**RE: The City of Greeley's Comments on NISP SDEIS**

**Resource Topic and Comment Number:** Surface Water #1

**Issue:** The NISP SDEIS selected a period of record that is not representative of the expected long-term operations of the Project.

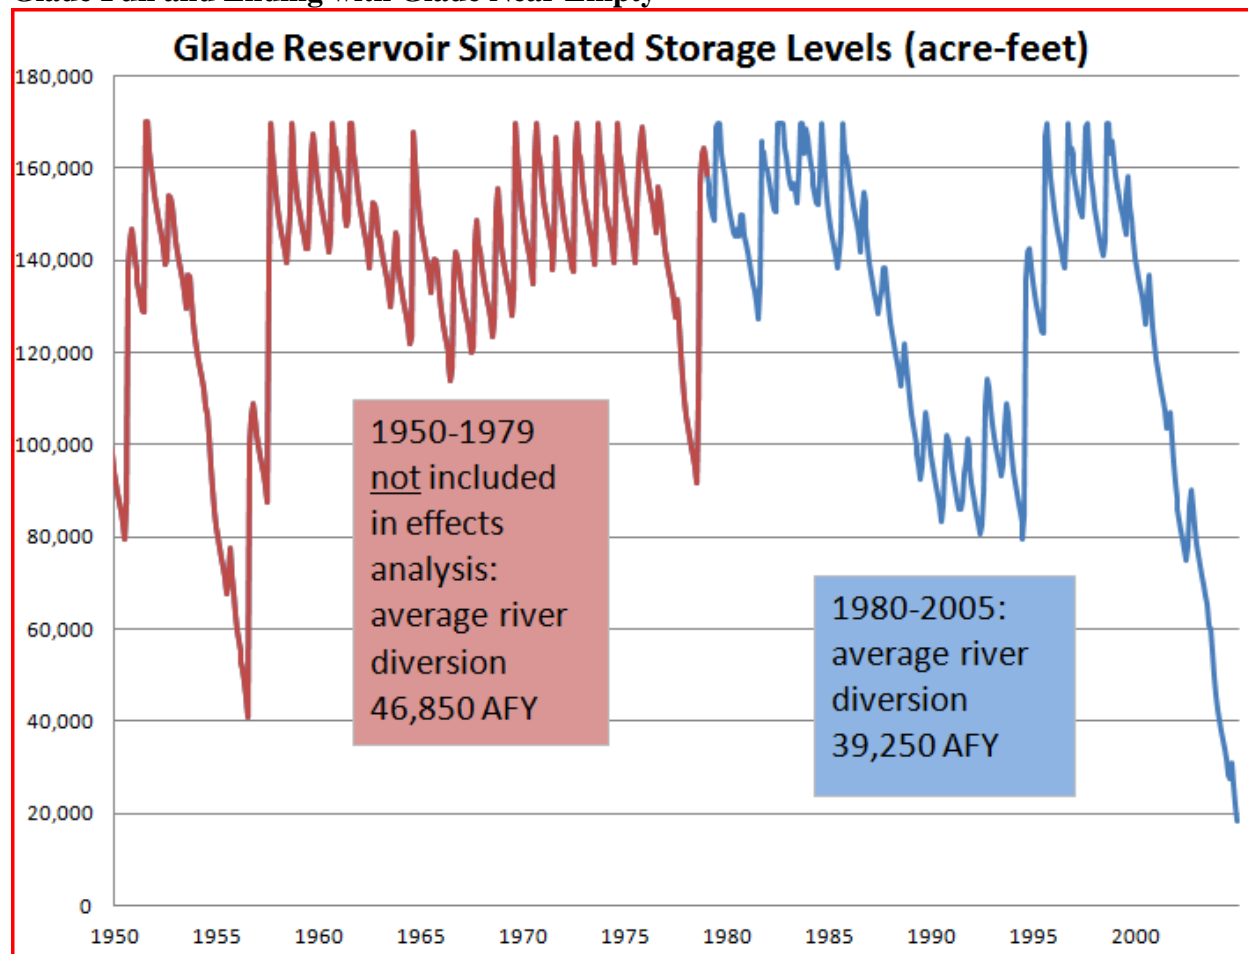
The U.S. Army Corps of Engineers (Corps) evaluated impacts using median values (as depicted in tables contained in SDEIS Volume I, Chapter 4, Section 4.2). A comparison of median project diversions for the full 56-year period of record (41,750 acre-feet per year [AFY]) against the median project diversions for the selected impacts analysis (36,502 AFY) shows that the project diversions during the selected years for the impacts analysis, (1980-2005), are not representative of long-term river depletions and are underestimated by more than 5,000 AFY.

This becomes a concern for Greeley for two reasons. First, the underestimation of project diversions could lead to an underestimation of other flow-related impacts that could create water quality issues at the City's Bellvue Water Treatment Plant (WTP) and its wastewater treatment plant (WWTP). Second, unaccounted-for impacts could potentially get shifted to other Corps' applicants, including Greeley.
